## VANGUARD Software Advisory Notice Release 6.1.T03A

This notice contains information on software improvements and changes made by the Vanguard Applications Ware Release 6.1.R000 patch 6.1.T03A which is based on 6.1.R000. This notice supplements the *Vanguard Applications Ware Release 6.1.R000 Software Release Notice* (Part Number T0001-42).

**Figure 1. Revision Number Label**

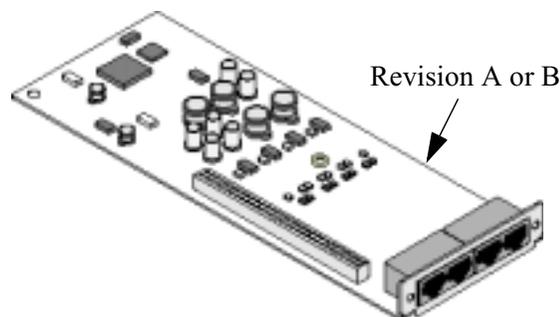
A manufacturing change in the SLIC chip design required the Quad FXS card to be revised from A to revision B. If you have a revision B Quad FXS card a 6.1 software patch is required (6.1.T03A). The Quad FXS revision B cards are not being recognized by software older than 6.1.T03A.

The arrow in Figure 1 shows the location of the revision label, located on the back right side of the Quad FXS card.
